## SYDNEY NORTH PLANNING PANEL

<b>Panel Reference</b>	PPSSNH-65
<b>DA Number</b>	DA6/2018
<b>LGA</b>	Lane Cove
<b>Proposed Development</b>	Section 4.55(2) application to modify approved demolition of remaining structures and basements, excavation to accommodate ten (10) basement levels including the provision of 316 public car parking spaces, construction of a fourteen (14) storey commercial building and two (2) mixed-use towers of twenty-six (26) storeys and forty-seven (47) storeys providing a total of 654 units and including a public library and retail space (including a supermarket), creation of a new laneway and public domain works at Christie Lane and Lithgow Street and associated works including tree removal, signage, and stratum subdivision.
<b>Original Consent</b>	DA6/2018 – Approved 28/11/2018 by Sydney North Planning Panel (Note: Consent issued 04/12/2018)
<b>Previous modification applications</b>	Nil
<b>Street Address</b>	71-79 Lithgow Street, 82-90 Christie Street, 84A Christie Street, 546-564 Pacific Highway, Christie Lane, and Lithgow Street, St Leonards.

**1 SUMMARY**

**Figure 9.** View from level 16 – **Approved DA** (Source: PTW Architects).

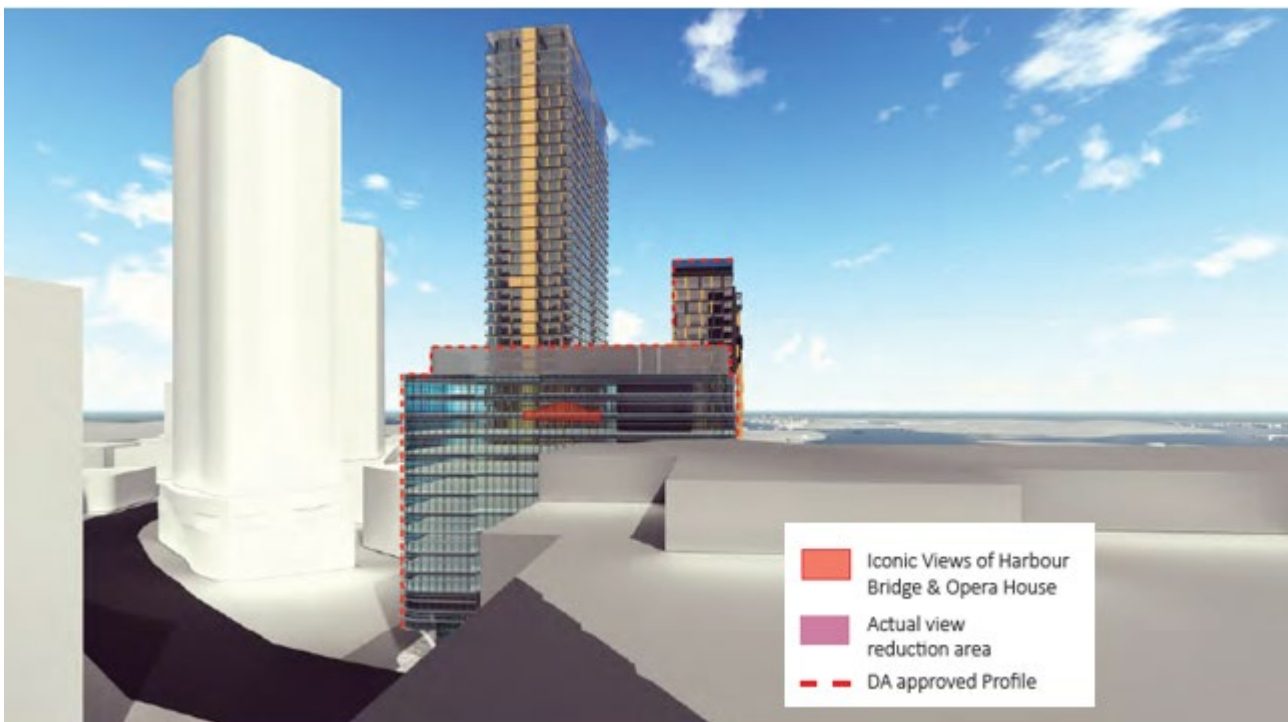
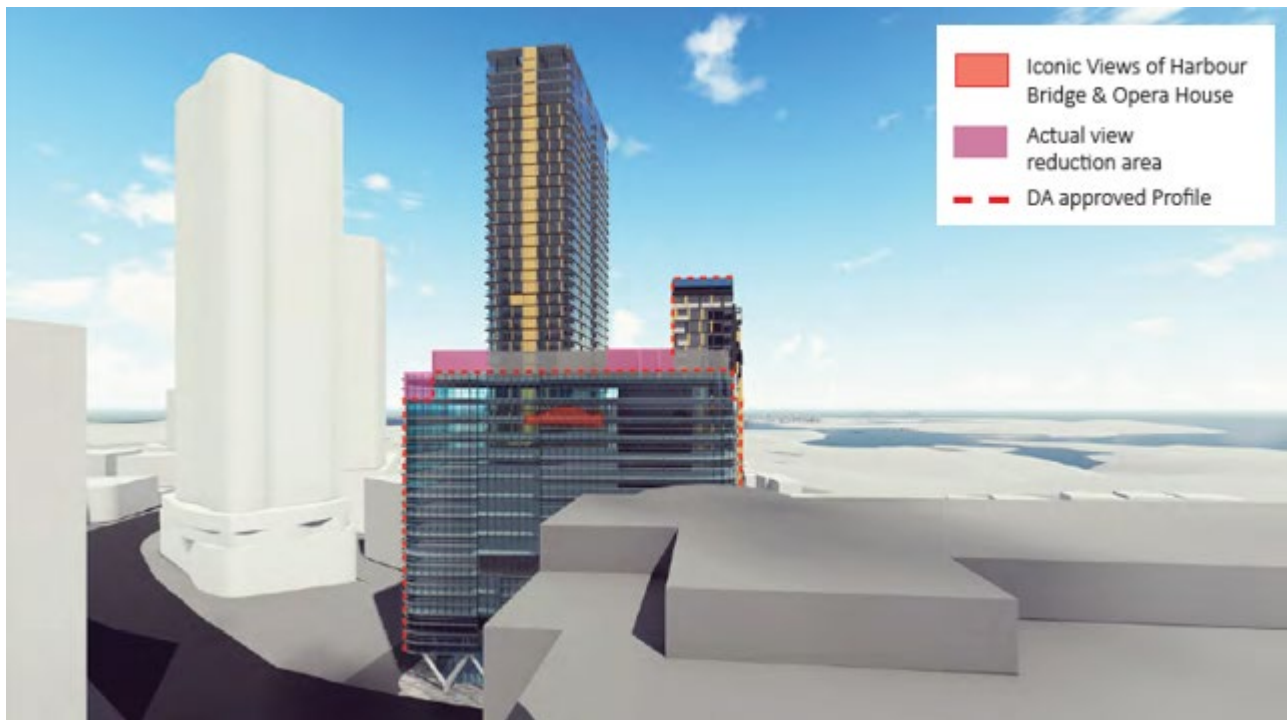
- The extent of view impacts to levels 16 to 25 of the *Forum East* residential tower is shown below:
  - o The increase in the overall height to T3 would have negligible impact on views between levels 16 (**Figures 8 & 9**) and 17 (**Figures 10 & 11**).

**Figure 12.** View from level 18 – **S4.55 Application** (Source: PTW Architects).

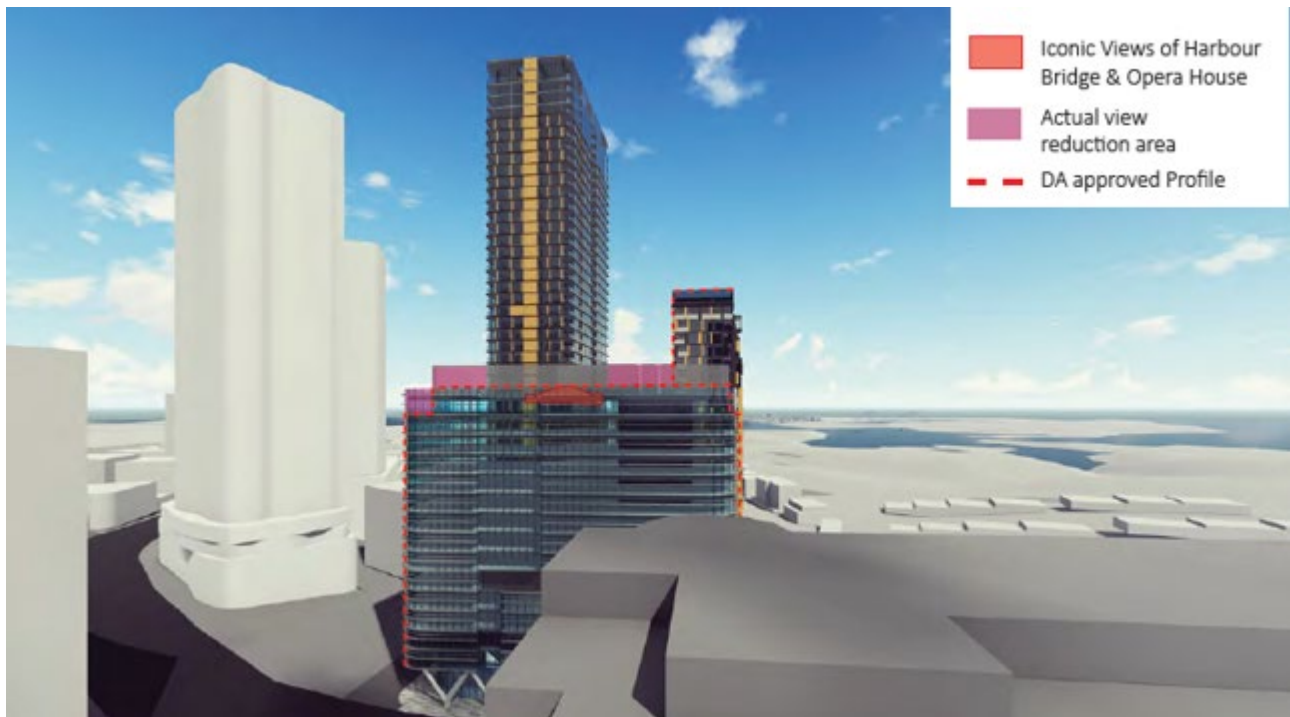
- At level 18, the increased height to T3 would obstruct views of the top of the centrepont tower (**Figure 12**). This is the only portion of the city CBD visible from level 18 (**Figure 13**). View impacts from level 18 are considered to be minor.

**Figure 14.** View from level 19 – **S4.55 Application** (Source: PTW Architects).

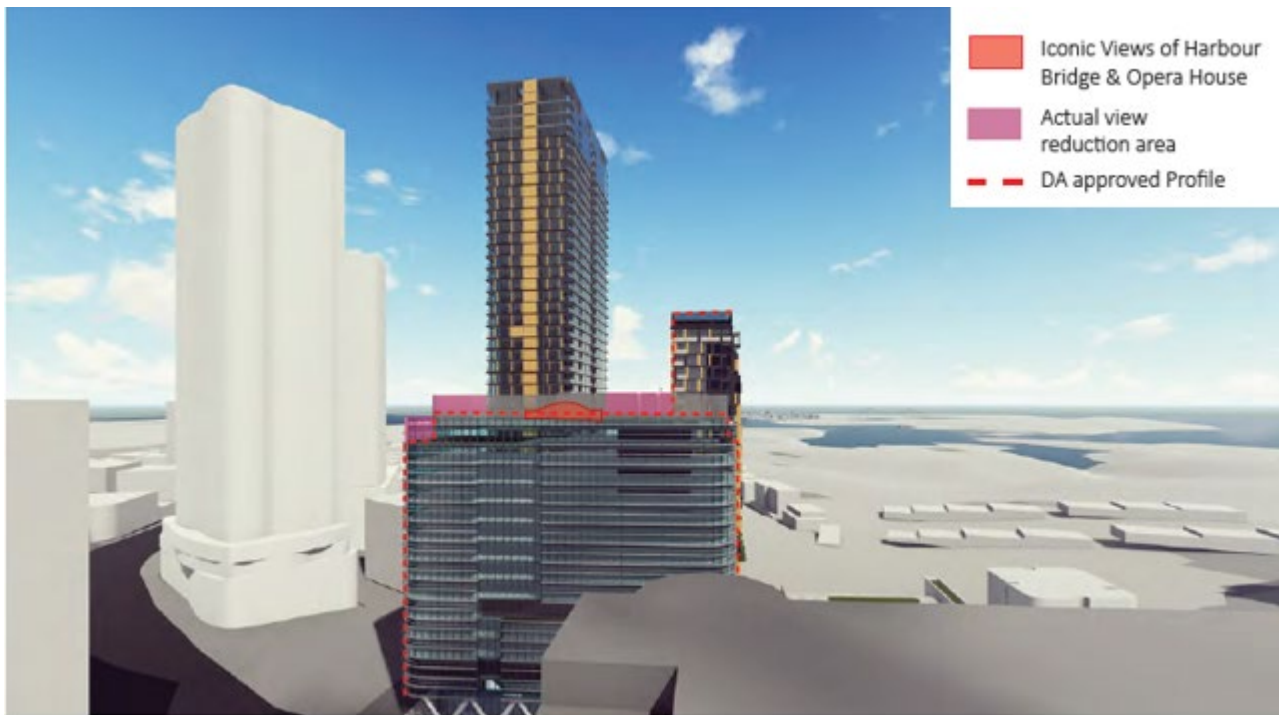
- At level 19, there would be some loss of views of the city CBD including centre-point tower (**Figure 14**). Views of the top of the Harbour Bridge above the approved building envelope are obstructed by the approved footprint of T1 (**Figures 14 & 15**). View impacts to level 19 are considered to be moderate.

**Figure 18.** View from level 21 – **S4.55 Application** (Source: PTW Architects).

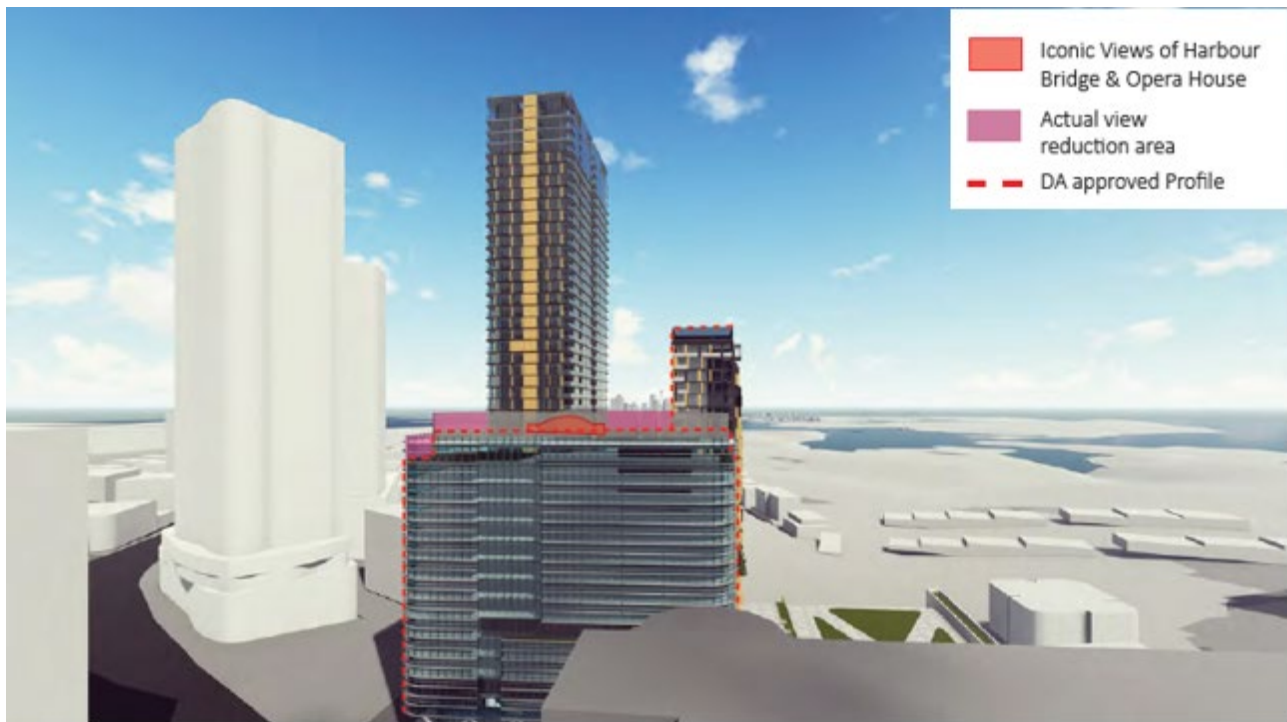
- At level 21, the CBD's interface with the skyline is clearly visible (**Figure 19**). The additional height to T3 would result in some view loss of the CBD (**Figure 18**). This view impact is considered to be minor. Views of the Harbour Bridge are obstructed by the approved development. The loss of water view to the east of T1 is minor.

**Figure 24.** View impact from levels 24 & 25 of the Forum East residential tower (Source: PTW Architects).

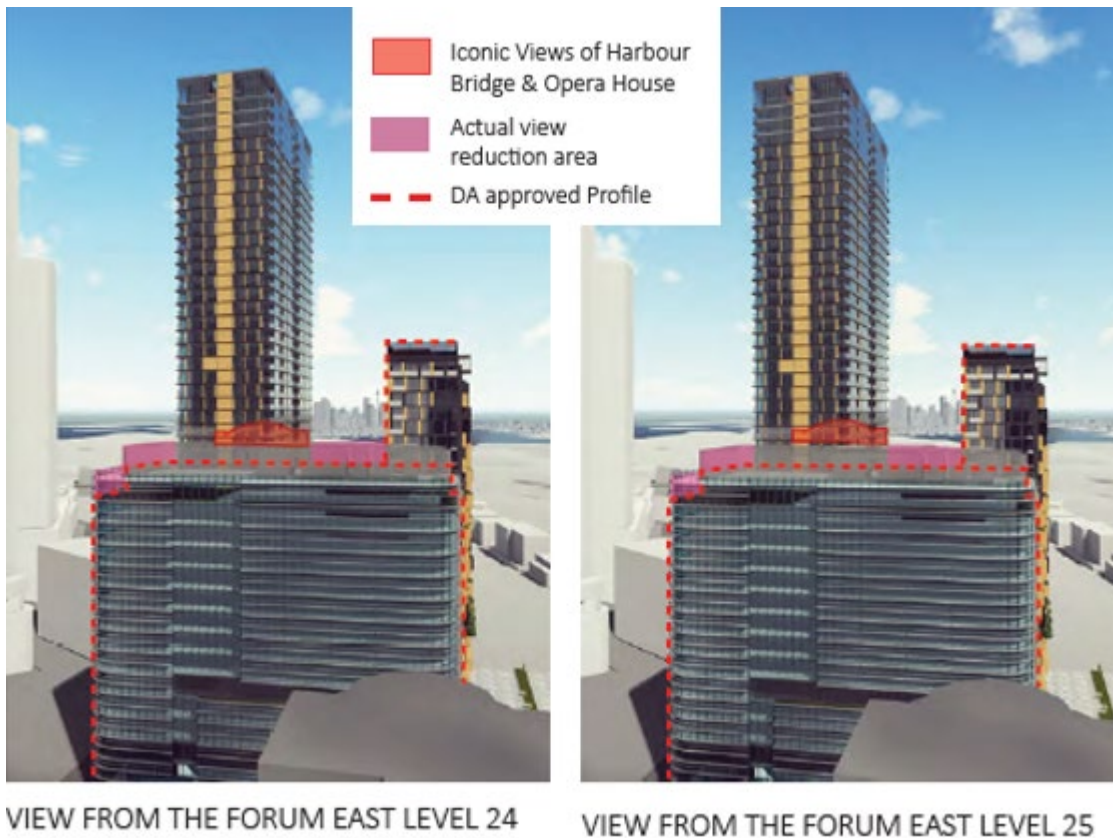
- At levels 24 and 25 and above, the increase in the overall height to T3 would have a negligible impact on city and iconic views. Water views to the east of T1 and views of the city skyline and Harbour interface are retained in full (**Figure 24**).

**Figure 26.** Impact on view corridor between T1 and T2 from the south-west apartment balconies at the Forum East residential tower.

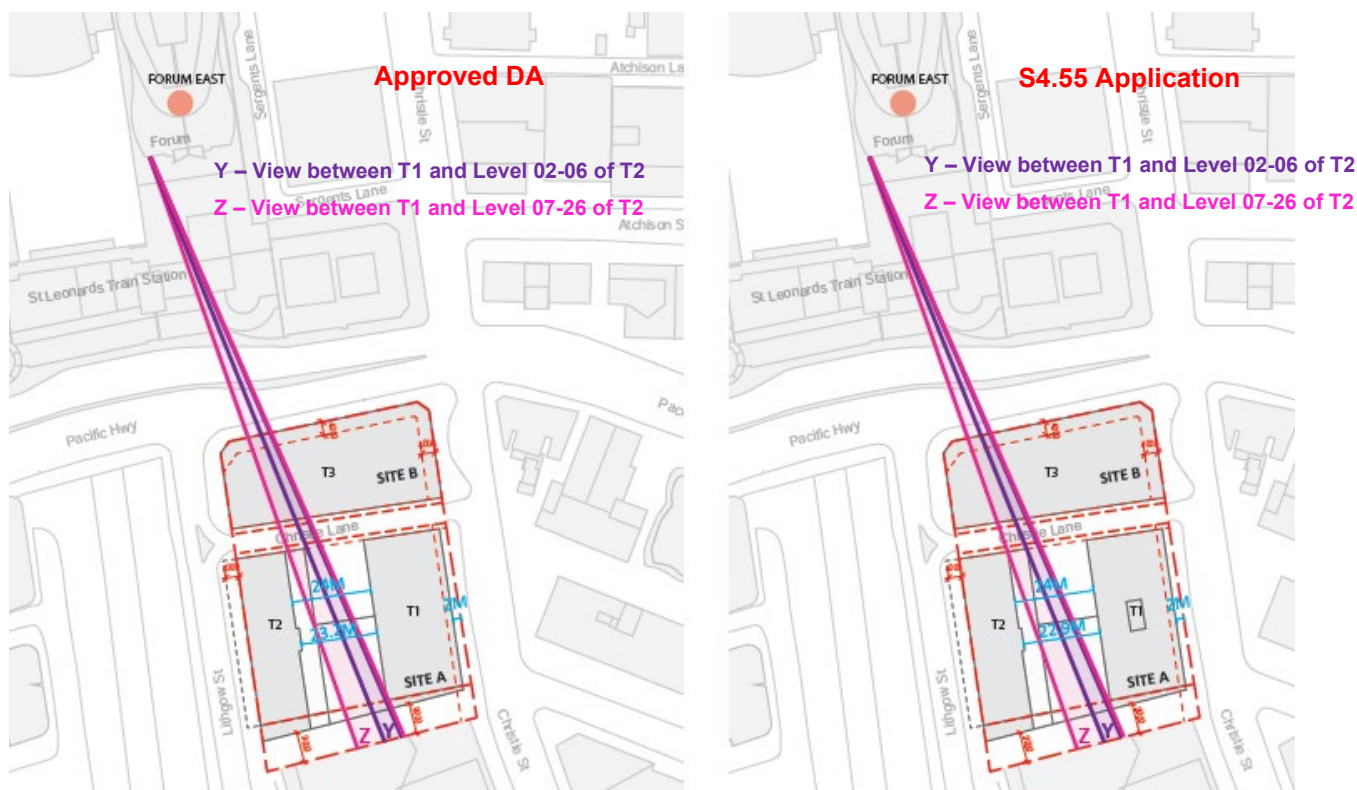
- There would be no change in views between T1 and T2 from the south-western apartment balconies of the Forum East residential tower (**Figure 26**).

**Figure 28.** Deletion of the northern awnings to T3 as per RMS requirements.

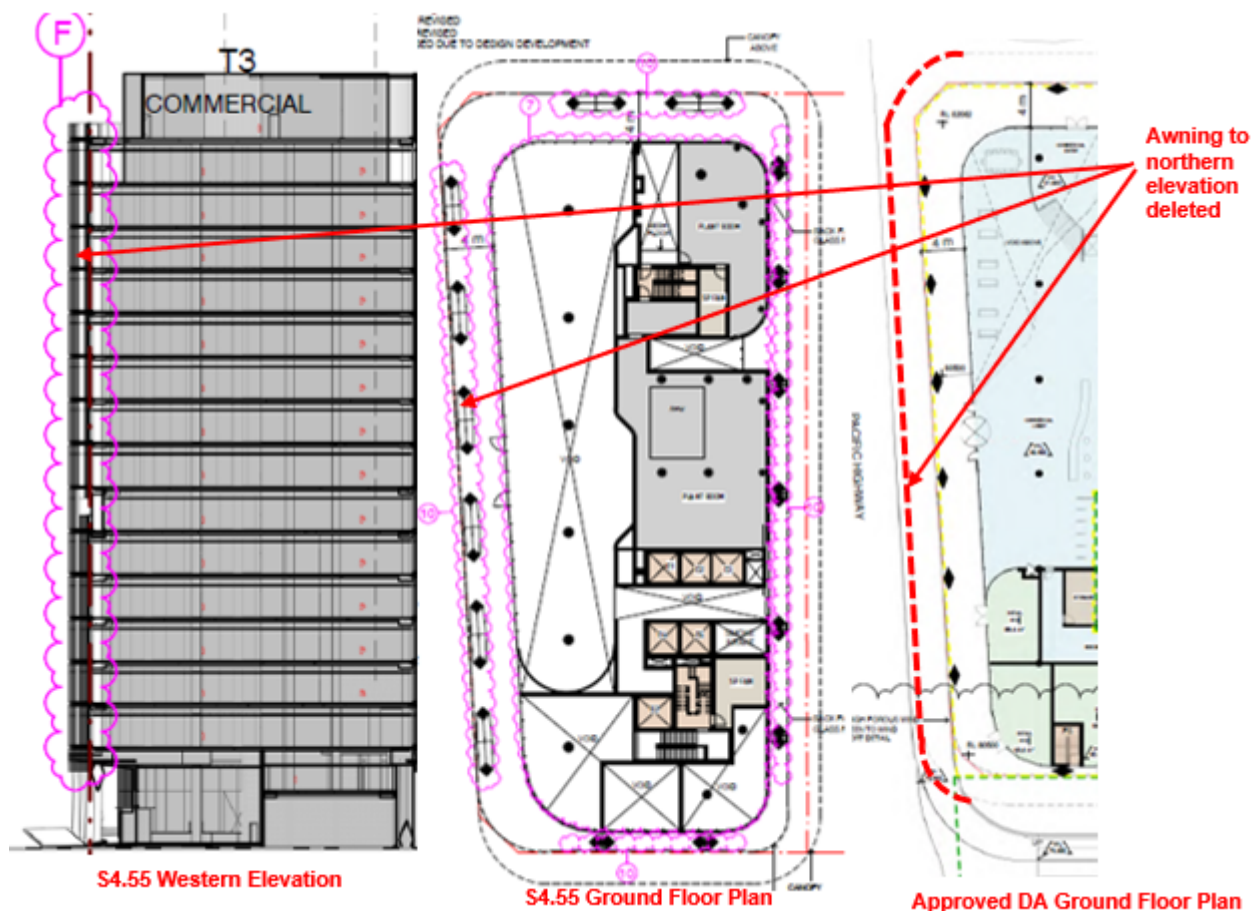
- The originally proposed awnings which encroached the freehold airspace have been deleted as per RMS requirements (**Figure 28**).
- Retention of the 4m setback and colonnade design would provide weather protection and pedestrian amenity.

**Figure 29.** Additional overshadowing cast by the increased height to T3 at 9am on 21 June on land zoned R2 Low Density Residential (Source: Drawing No. DA-93-0101, Rev C dated 17/01/20/20, prepared by PTW Architects).

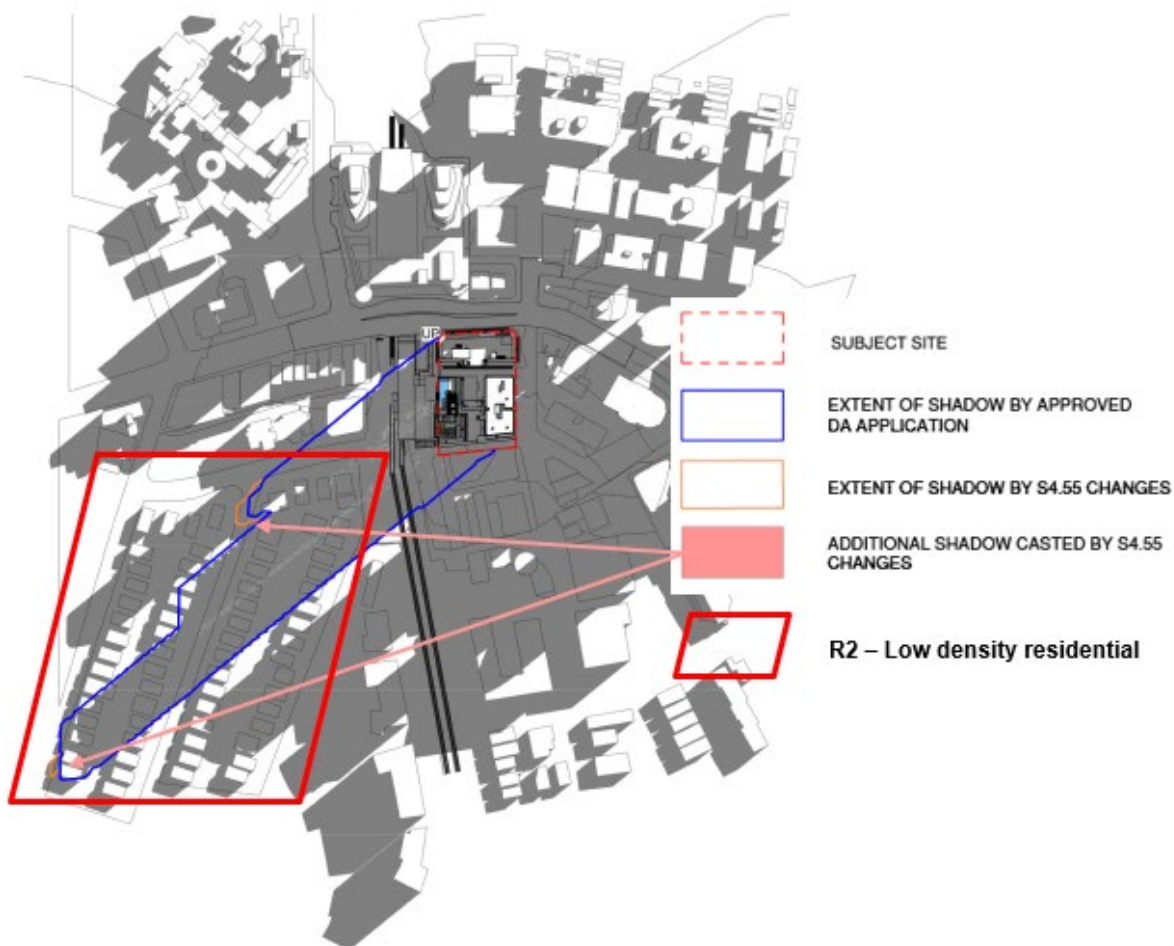
- Additional overshadowing impacts from the increase in height to T3 is negligible, as follows:
  - at 9am on 21 June, some minor additional overshadowing will occur to a portion of the front setback of two R2 Low Density residential zoned allotments on Berry Road to the south-west of the site (**Figure 29**);
  - at 12 midday, minor additional overshadowing will occur to a small section of road reserve on Lithgow Street and small portion of land zoned B3 Commercial Core to the south of the site, and a small section of the railway corridor (**Figure 30**); and
  - at 3pm, some minor additional overshadowing will occur to a small portion of land zoned b3 commercial core and R4 high density residential to the south-east of the site (**Figure 31**).
- No additional overshadowing will occur to the civic plaza.
